PROPOSED AND EXISTING ELEVATIONS.

PROPOSED REAR EXTENSION AND INTERNAL ALTERATIONS AT 93, CEMETARY ROAD HEMINGFIELD, BARNESLEY, S73 0QG. FOR MR & MRS S. LOY.

DRW.	SCALES.
DATE NOV. 2019.	1:50 METRIC.
DRAWING No. NEW-BA-02.	REVISION. 0.

PROPOSED REAR ELEVATION.

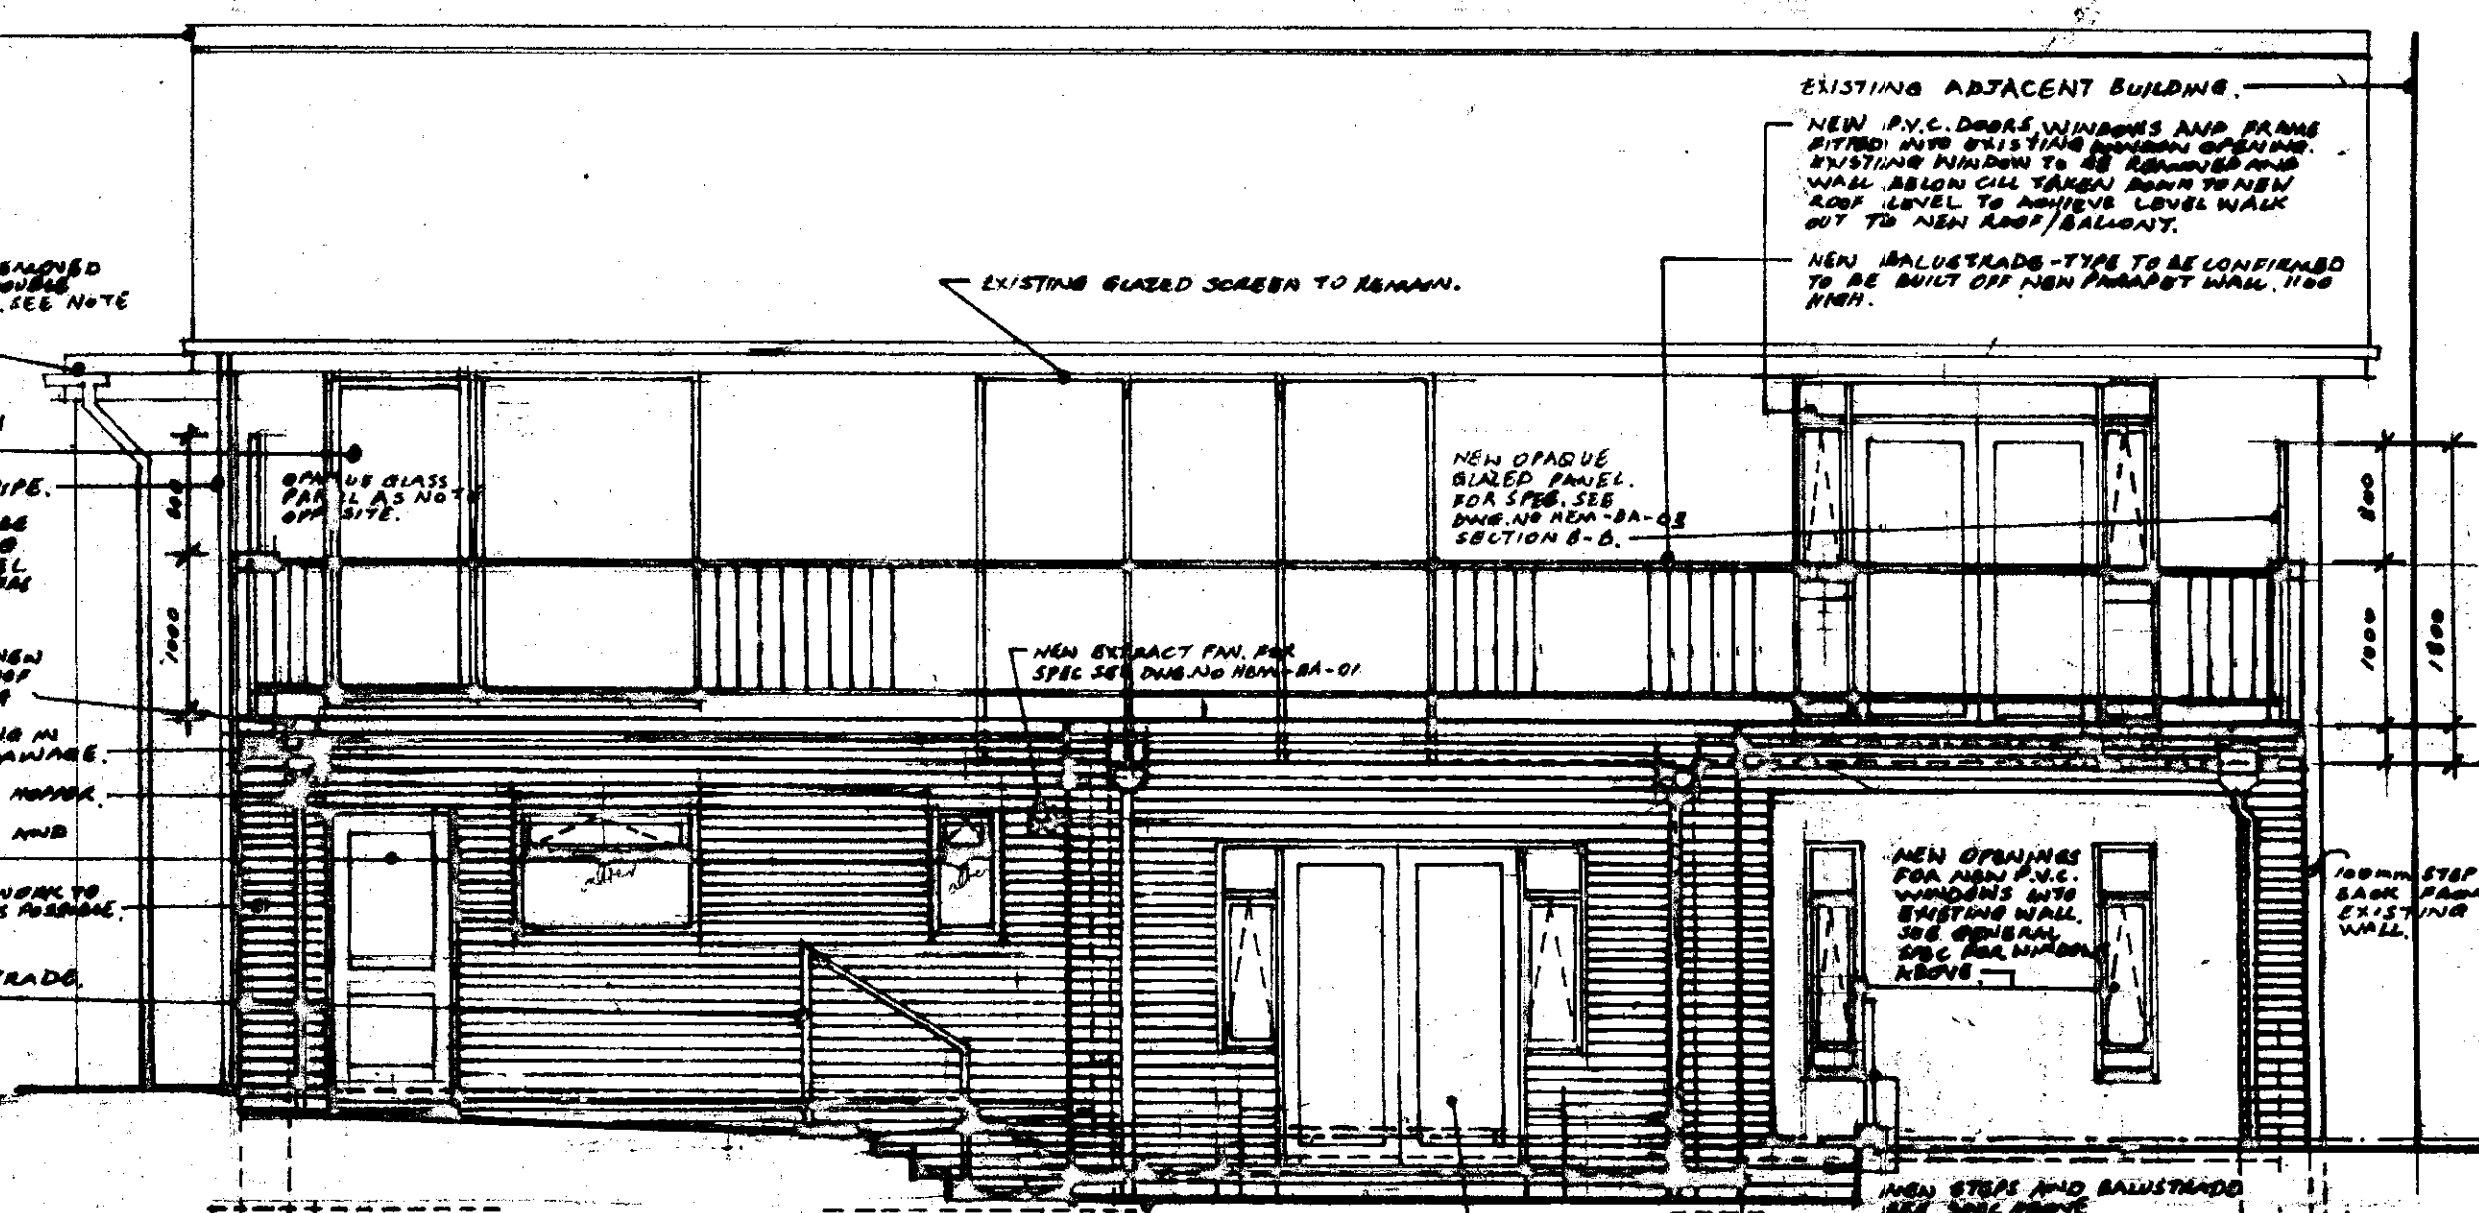
REF.	REVISION.	DATE.
C.	OPADUE GLAZED PANEL AS REVISION. B. BUT TO LEFT HAND WALL.	FEB. 10
B.	OPADUE GLAZED PANELS TO NEW PARAPET WALL TO GIVE A TOTAL HEIGHT OF 1.8M. PARAPET WALL REQUIRED TO 1.8M HEIGHT. REVISION ON BRICKWORK WITH DET. OF FINISHING REQUIREMENTS BARNESLEY, M.S.O.	25.01.24
A.	WALL TO END OF BALCONY ADJACENT TO SIDE ADJACENT WITH 100MM CONCRETE ROOF INCREASED IN HEIGHT FROM 1.47M TO 1.8M TO COMPLY WITH REQUIREMENTS OF BARNESLEY M.S.O. DET. OF FINISHING	09.02.24
